Grading &
Drainage
2013075

DRAINAGE REPORT

**FEDEX GROUND ABQ
ALBUQUERQUE, NEW MEXICO**

**RE: FEDEX GROUND FACILITY
TOWN OF ATRISCO GRANT UNIT 5
DRAINAGE REPORT AND PLANS UPDATE**

ENGINEER'S SEAL		FEDEX GROUND ALBUQUERQUE, NM		DRAWN BY DY	
		PRE DEVELOPED DRAINAGE BASIN MAP		DATE 7-3-14	
		TERRA WEST, LLC 5571 MIDWAY PARK PLACE NE ALBUQUERQUE, NM 87109 (505) 856-3100 www.terrawestllc.com		2013075-BASINS	
				SHEET # C2	
RONALD R. BOUWMAN P.E. #7868				JOB # 2013075

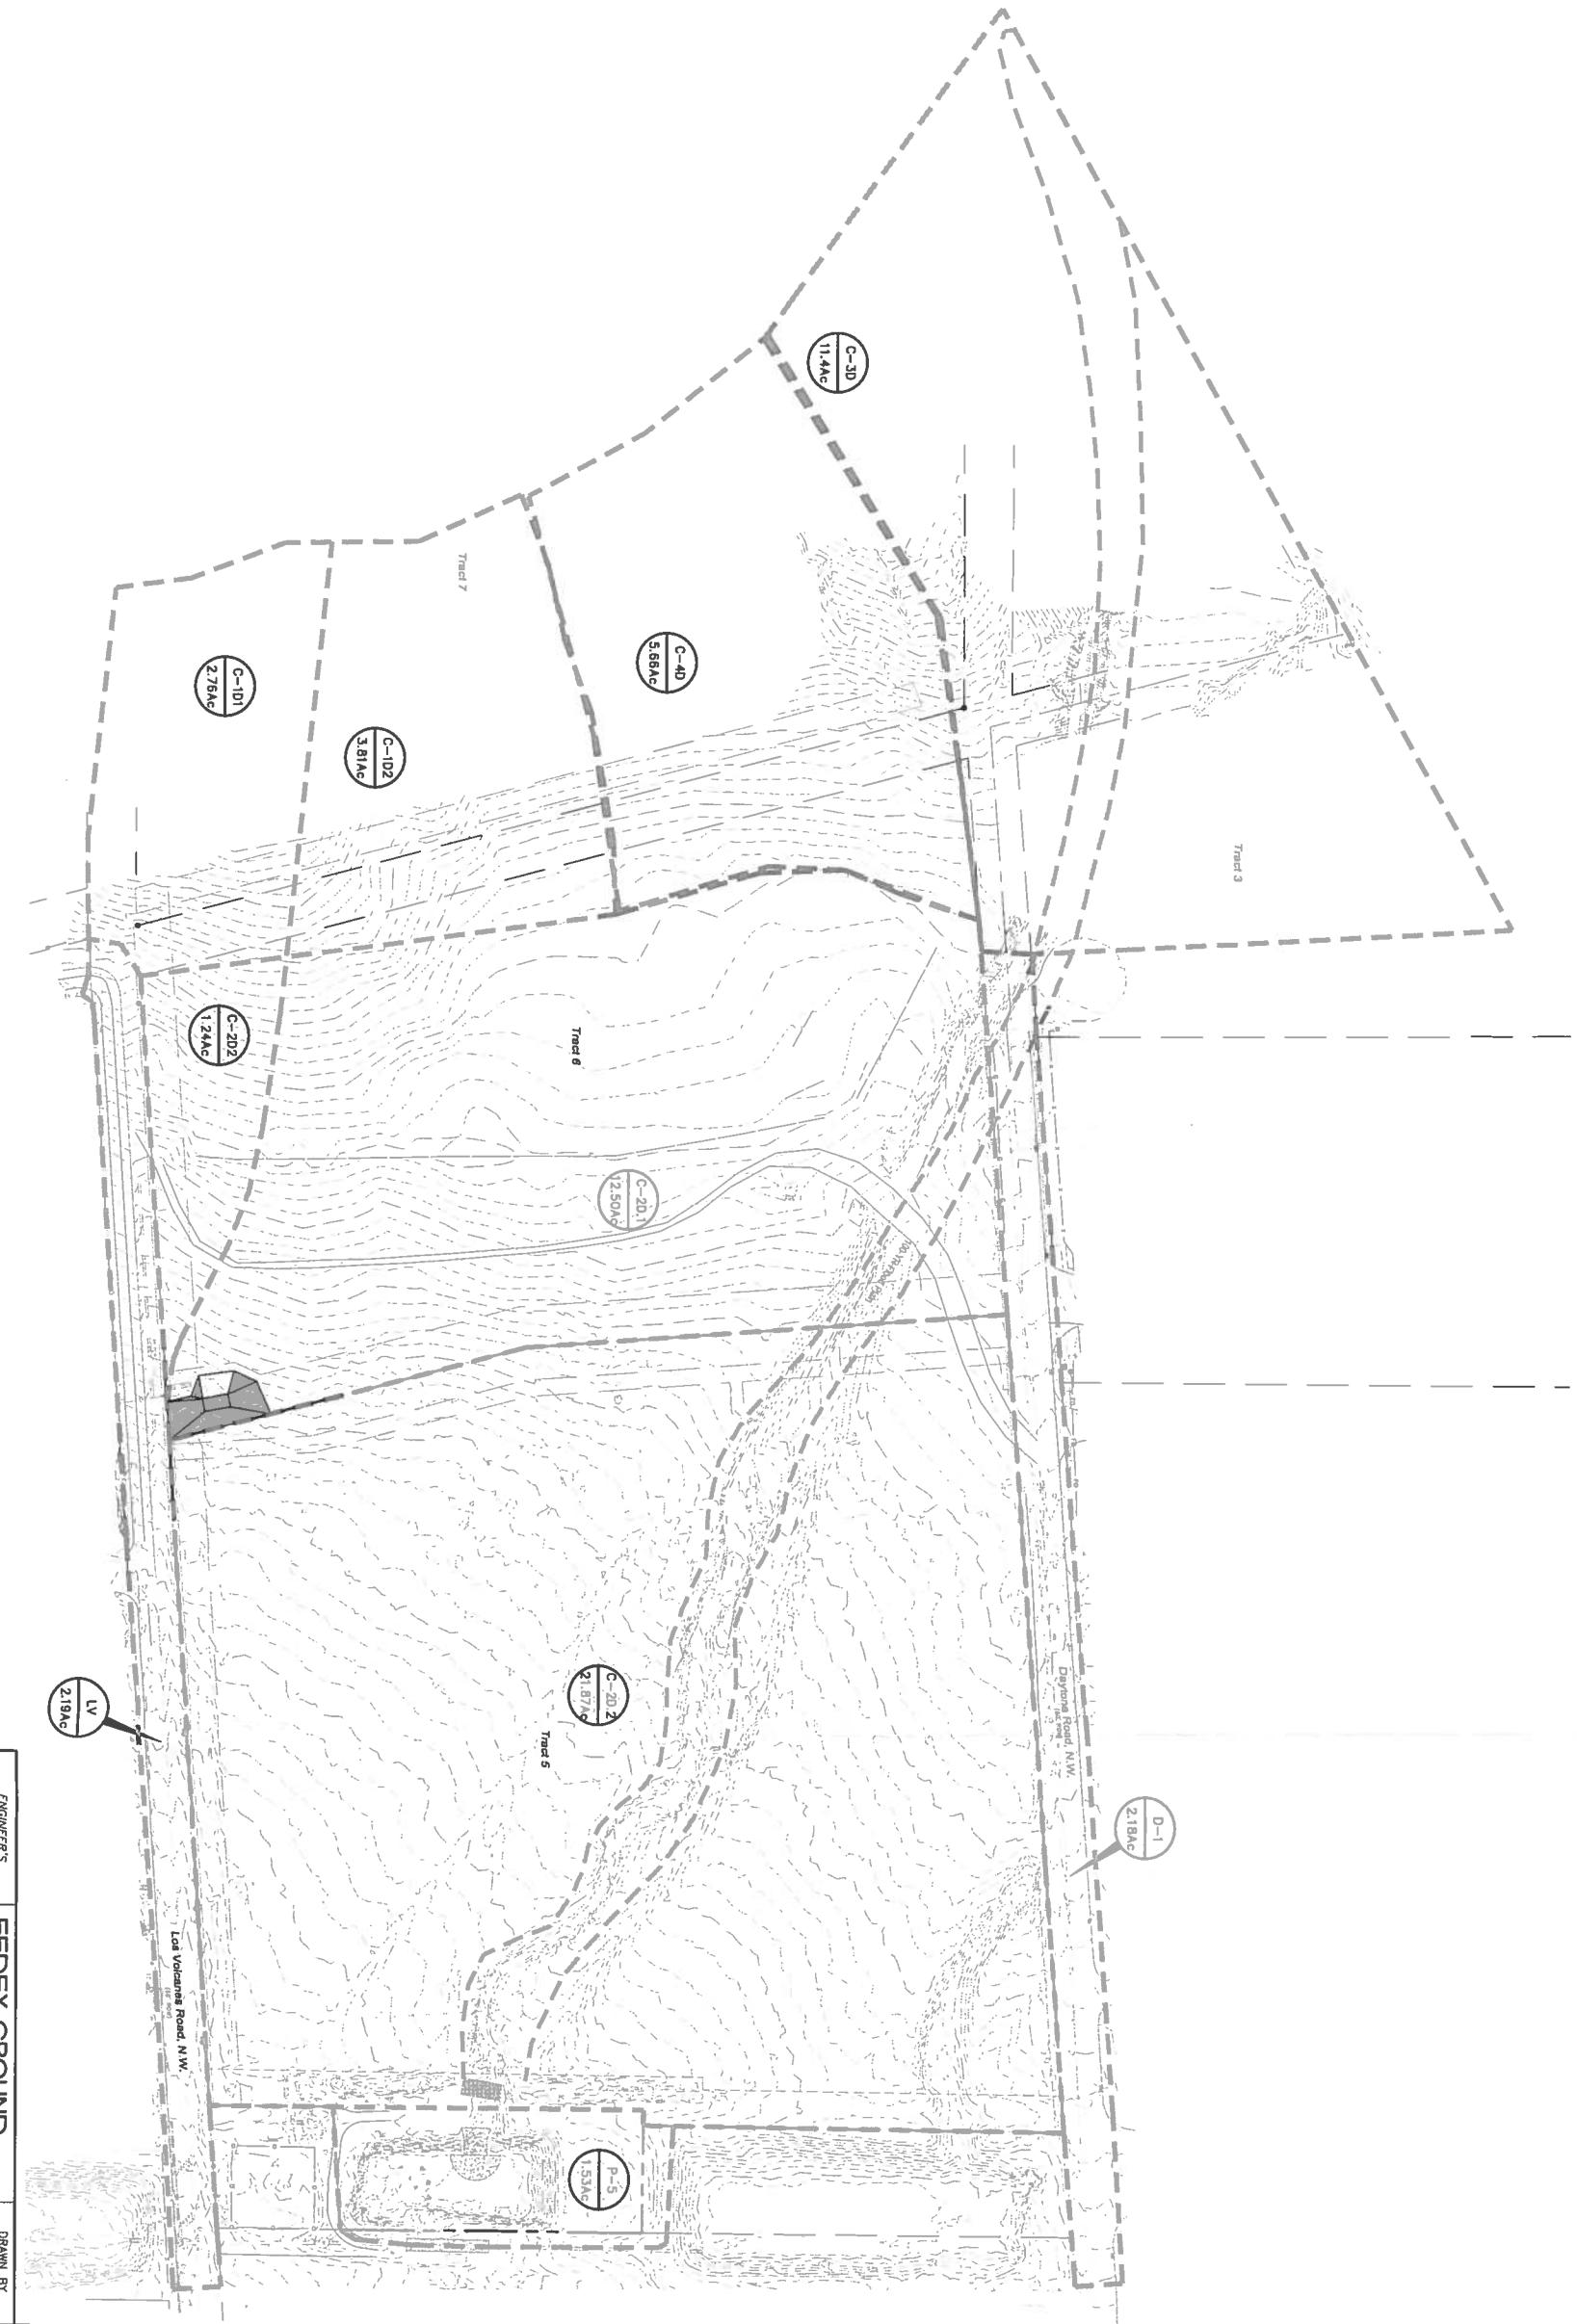
1. The area in the existing conditions that drains to this site appears to be closer to 37 ac, not the 12.5 ac in the report. Show the extents of the offsite basin on a plate.
An Exhibit with the drainage basins under existing conditions was added. Acreages are correctly shown on the exhibit. Drainage from Basin C-3D will be intercepted by the Daytona storm drain that will be extended west into the existing arroyo. A sediment pond will be constructed outside the right of way, upstream of the inlet to the storm drain. Flows from basins C-4D, C-2D.1 and C1D.2 will be intercepted by the proposed swale west of the FedEx property line and conveyed to the Los Volcanos storm drain that will be extended as part of this project. A sediment basin will also be constructed at the inlet to this storm drain. Flows from basins C-1D.1 and C-2D.d will continue to drain to the Los Volcanes right of way as they currently do today.

ALBUQUERQUE METROPOLITAN
 ARROYO FLOOD CONTROL
 AUTHORITY
 TITLE: UNDER DIVERSION
 OUTLET STRUCTURE
 DETAILS AND SECTIONS

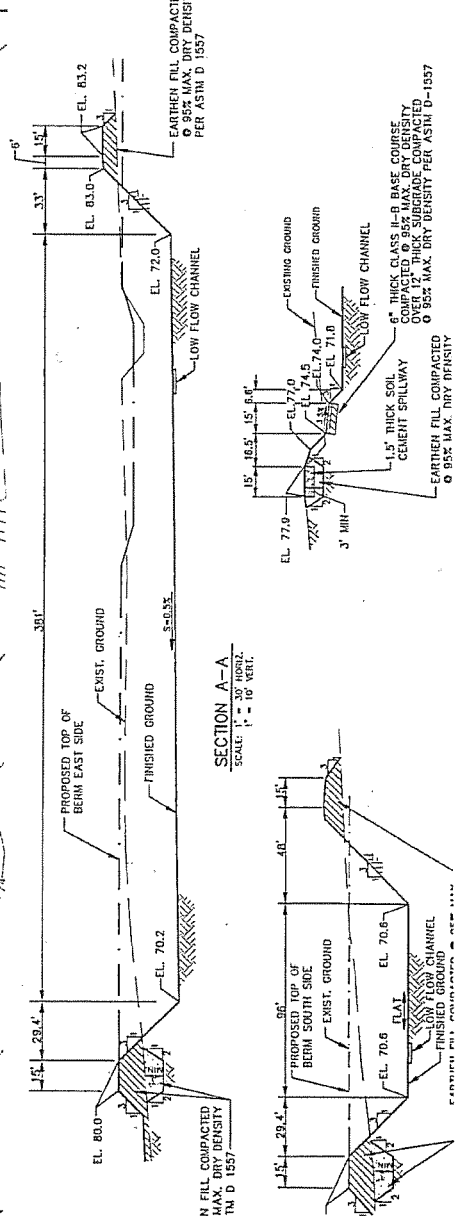
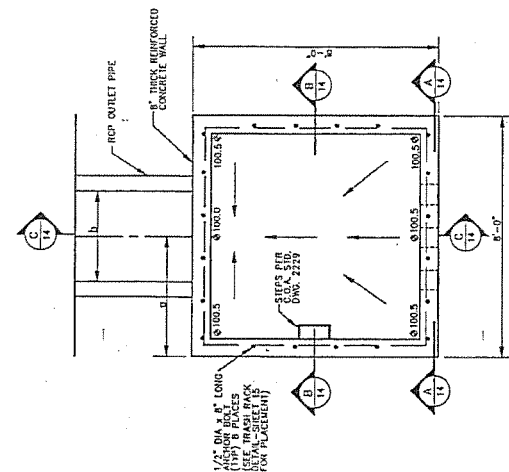
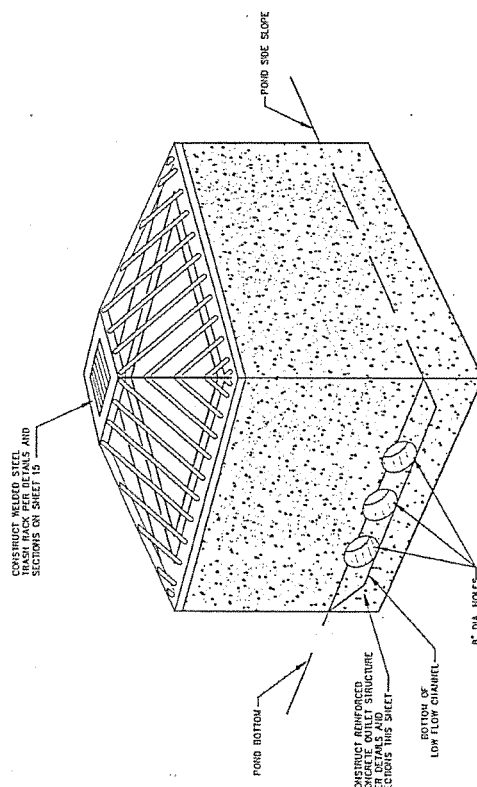
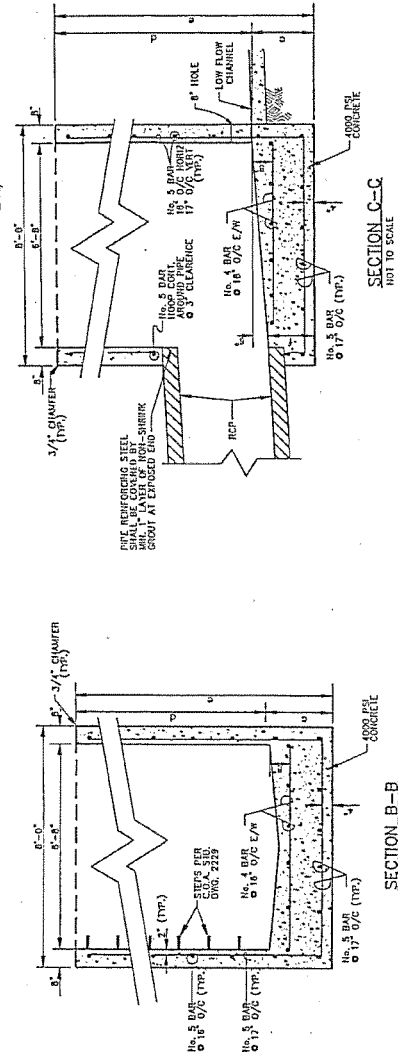
- The plan was not reviewed at the building Permit level; however, when submitting for Building Permit the following items should be addressed:
11. The outlet structure for Pond 5 is to be modified as the existing 8" holes easily plug. Hydrology would like a ported riser design. In addition, provide the as-builts for the outlet structure.
A detail for the modification of the Pond 5 outlet structure to include a ported riser was added to the plans. The as-builts for the existing outlet structure are attached.
